Staff Report

Chippewa Falls/Eau Claire Urban Sewer Service Area Plan Request for Type I (“Land Swap”) Amendment

9/7/2022 Summary

TYPE 1 SEWER SERVICE PLAN AMENDMENT - Orchard Hills

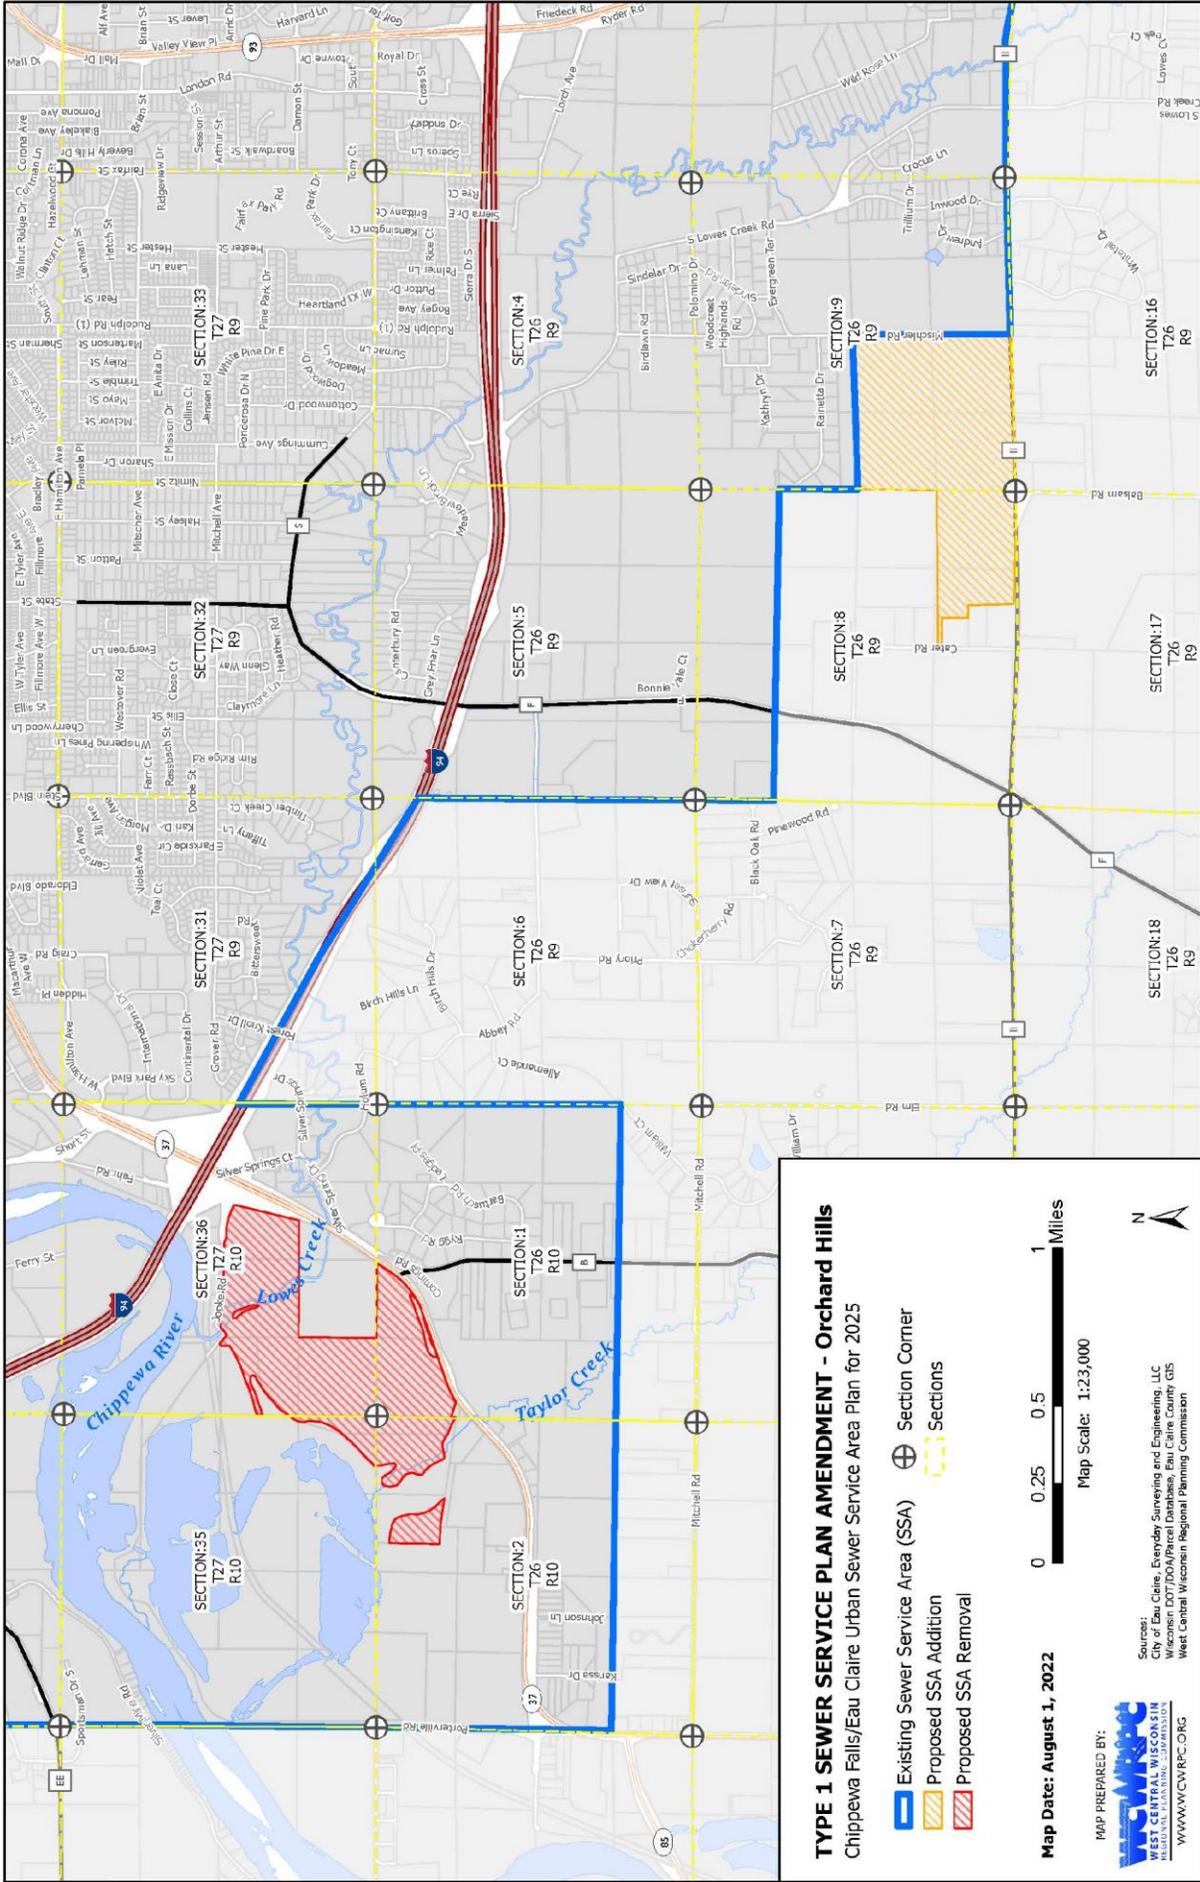
Sanitary sewer extensions beyond the 20-year urban sewer service area (SSA) boundary are not permitted unless the SSA Plan is amended. The City of Eau Claire has submitted a Type I SSA Plan Amendment (or “land swap”) application that would modify the SSA boundary as generally described below and as shown on the map at the end of this summary:

- **Remove** 219.8 acres from the Sewer Service Area located within Sections 2, 35, and 36, T27N, R10W within the Town of Brunswick (*the “donor” area*).
- **Add** 219.64 acres to the Sewer Service Area located within Sections 8 and 9, T26N, R9W, within the City of Eau Claire (*the Orchard Hills “receiving” area*). The receiving area is part of the proposed Orchard Hills development, of which two parcels totaling 18.6 acres are already located in the SSA.

- i. Given the extensive 100-year floodplain area and the lack of known plans to provide sanitary sewer service to the 219.8-acre donor area within the Town of Brunswick, **it is agreed that the donor area is an environmentally desirable candidate to be removed from the Sewer Service Area.** This is recommended even though a strict interpretation of Policy 1.1.9 suggests that a boundary amendment shall not create a void within the SSA. Given that the SSA Plan is a water quality plan and that the donor area is in fairly close proximity to the boundary, it is our opinion that the removal of the acreage and its ESAs from the SSA outweighs the strict adherence to Policy 1.1.9 when considering the goals and objectives of the SSA Plan overall. During the next SSA Plan update, it is recommended that large, continuous environmentally sensitive areas be removed from the SSA if such ESAs would otherwise span the border of the SSA.

- ii. **It is appropriate to amend the SSA Plan boundary to include the 219.64-acre Orchard Hills receiving area.** When considering the urban area as a whole, connecting compact, higher-density development to municipal water and sanitary sewer generally affords a higher level of water quality monitoring and protection than low-density development on private wells and septic systems. Any concerns related to the environmentally sensitive areas (ESAs) and the final siting of the sanitary sewer extension must be addressed as part of the 208 conformance review process.
